1. **930 Fort Street - Rezoning Application No. 00593 & Development Permit with Variances Application No. 00502 (Downtown)**  
***An application to allow the construction of a 13-storey, mixed-use building containing 62 residential units and two ground-floor commercial units.***

**Committee of the Whole Report**  
**For the Meeting of April 12, 2018**

# Proposed Mid-Rise Residential

EAST ELEVATION  
& WEST ELEVATION

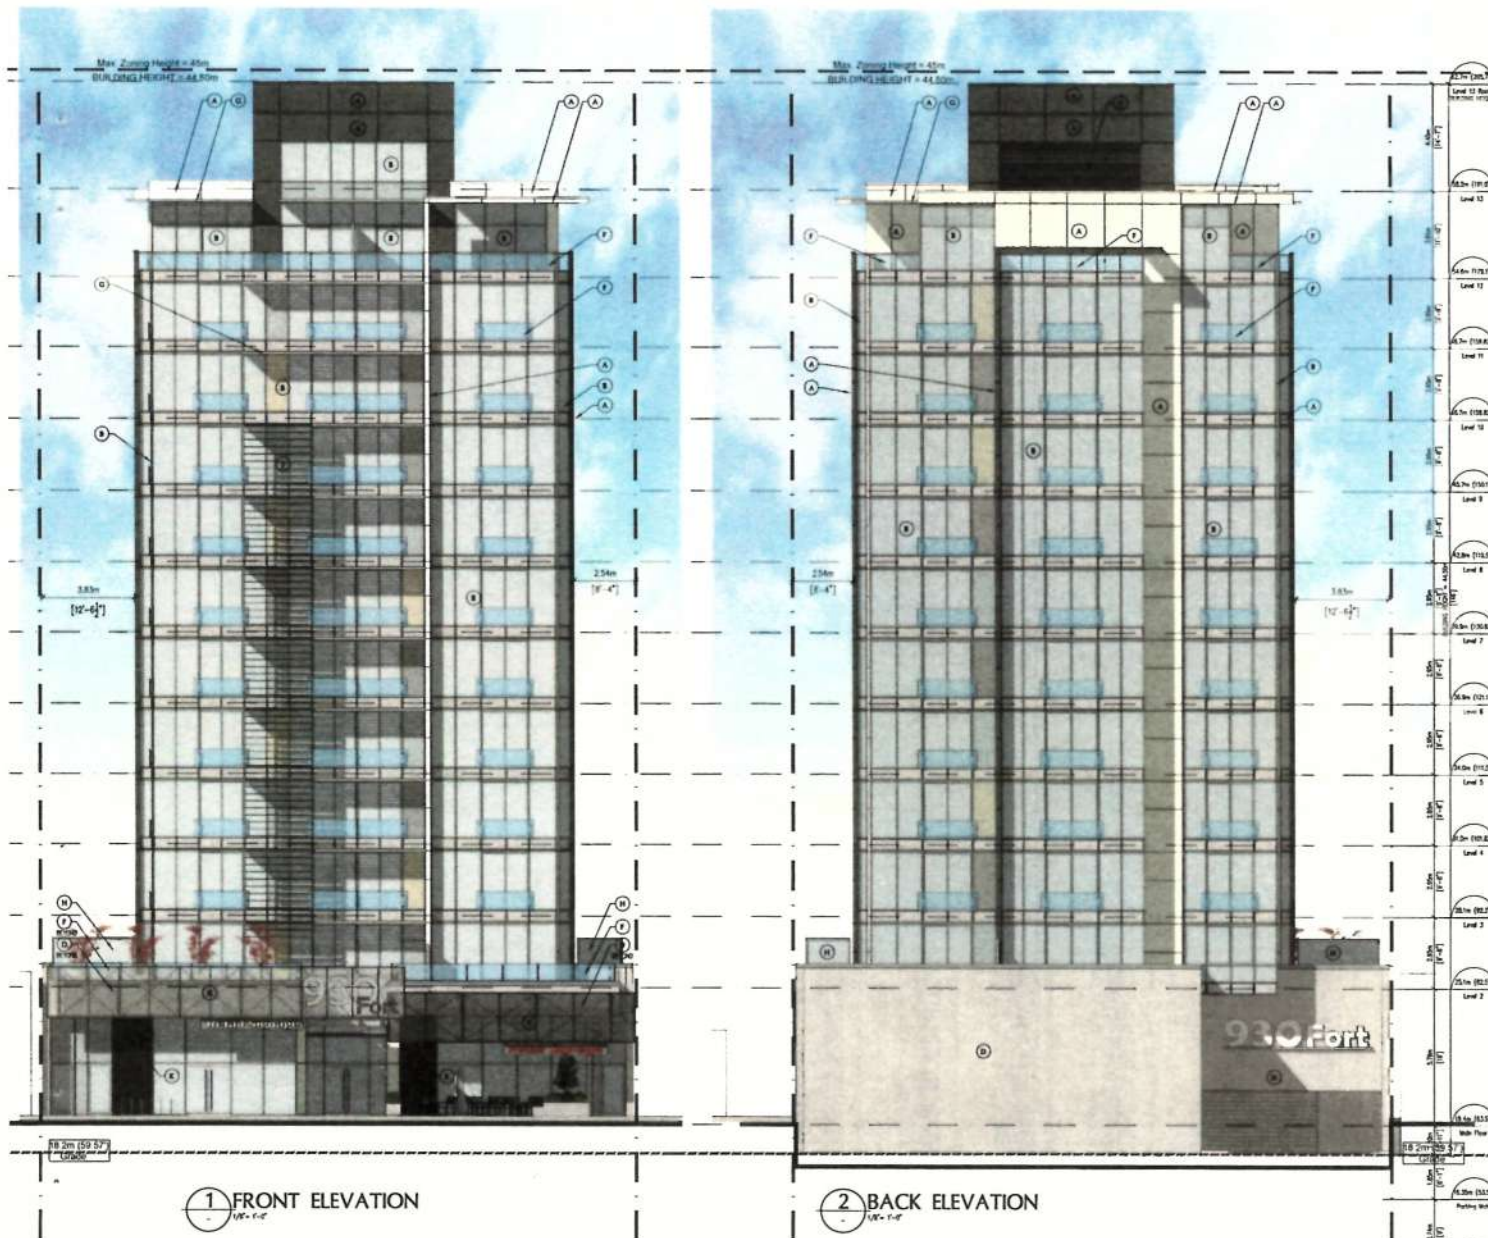
- a. provision of distinct, well-defined retail bays, consistent with the context along Fort Street.
- b. revisions to the tower to address the uniform appearance, with particular attention to the north and side elevations.

c. revisions to the scale and materials of the podium to provide a more sensitive response to the immediate context within the Heritage Conservation Area.
